SERVICE LETTER 179

FIREBOSS WATER RUDDER PULLEY CLAMP REPLACEMENT

Aircraft Makes/Model(s):	Float Model(s):	Compliance: Optional	By: RCG
Air Tractor AT-802, AT-802A	10000A	Part Number: 1009448	Approved: JRS
		Date: 6/20/2018	Revision: A

Showing left installation only, mirror assembly and components when applicable for opposing side

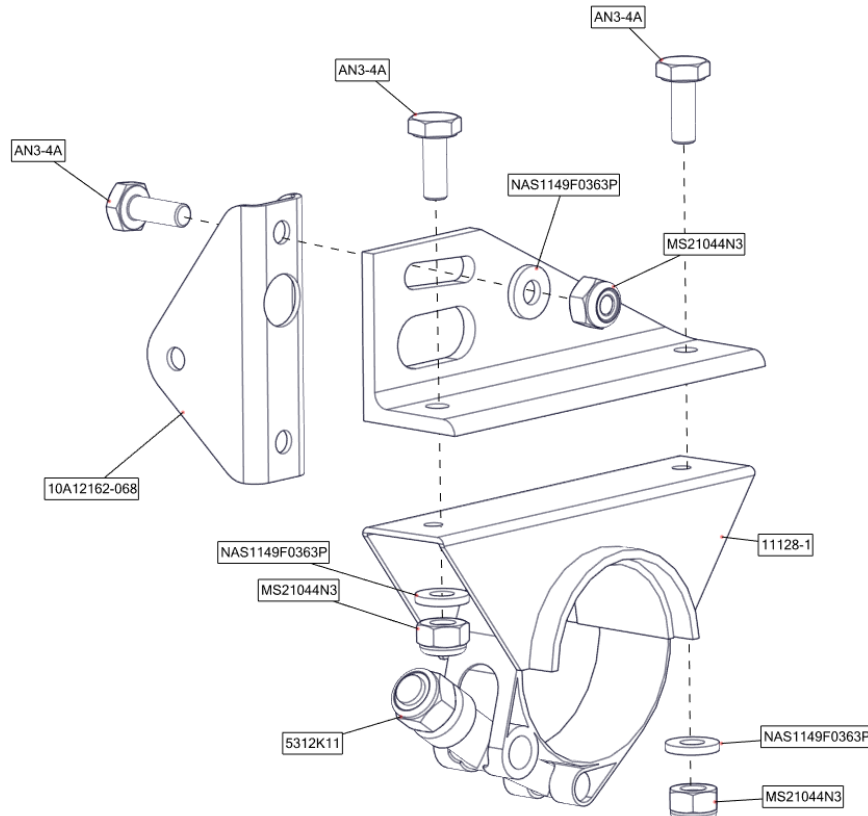
1. Disconnect steering cable in the tail and loosen or remove necessary components in order to feed steering cable back to fuselage station 62.63 pulley bracket assembly
2. Remove existing pulley bracket assembly from fuselage station 62.63
3. Cut and adhere 10A12566-010 clamp gasket to 11138-1 arch bracket as shown

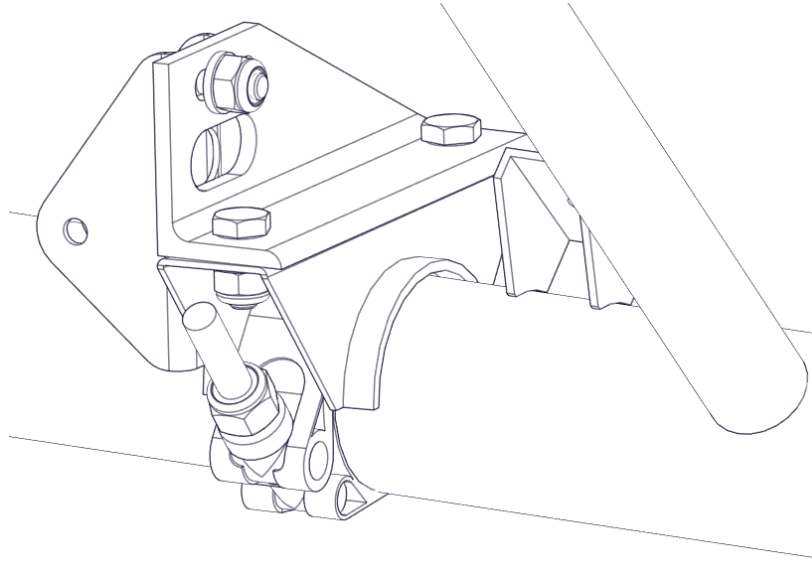
4. Loosely place new 5312K11 bolt clamp through 11128-1 arch bracket and reassemble pulley bracket assembly (excluding the (2) MS24566-1B pulleys and 10A08339-073 cable stop) as shown

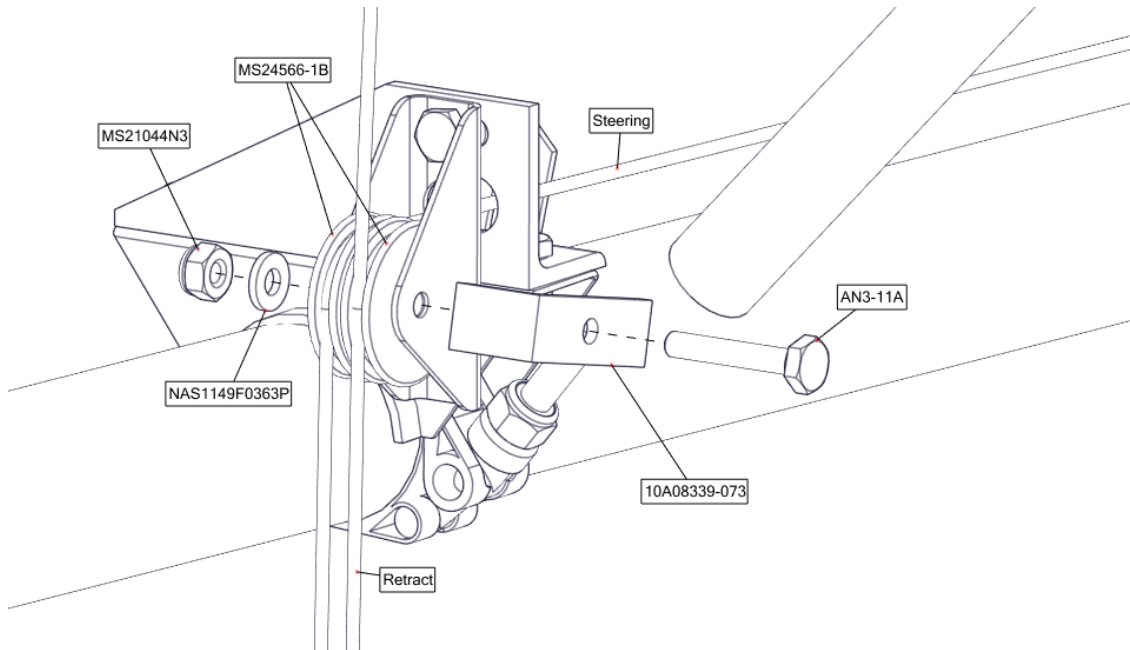
- Determine the position of the pulley bracket assembly along the longeron in reference to the retract and routing cables and tighten 5312K11 bolt clamp to fuselage station 62.63 as shown. Adjust 10A12162-068 fuselage pulley bracket in slot position if needed
